# Service Bulletin

Bulletin No.: 20-NA-020

**Subject: Brake Squealing Noise**

Brand:	Model:	Model Year:		Vehicle Build Date:		Engine:	Transmission:
		from	to	from	to		
Chevrolet	Silverado 2500HD/3500HD	2020	2022				
GMC	Sierra 2500HD/3500HD

5638987

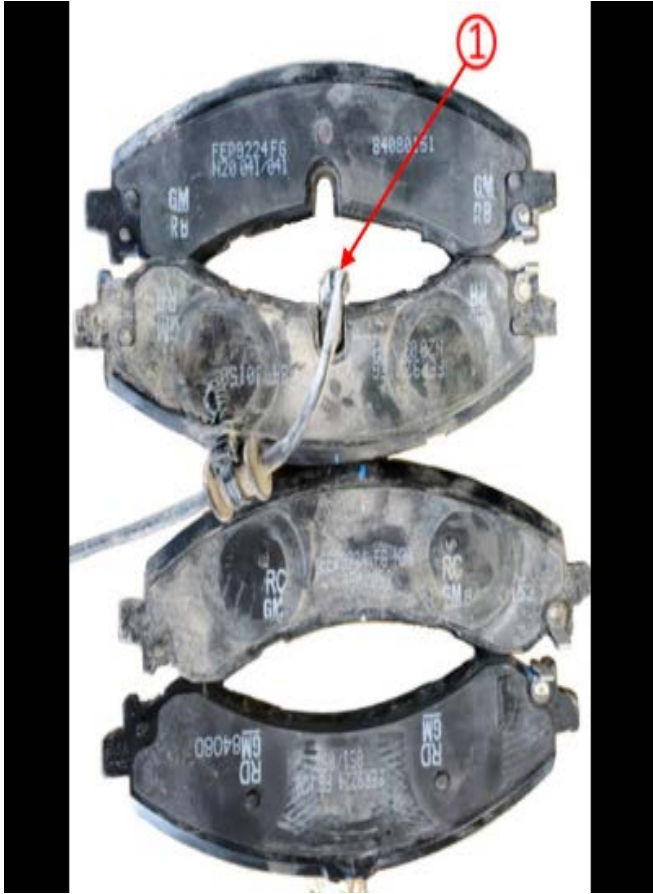
**Important:** Only the left side of the truck has the wear sensors (1) and is mounted on the inner pad. Refer to *Front and Rear Disc Brake Pads Replacement* in SI.
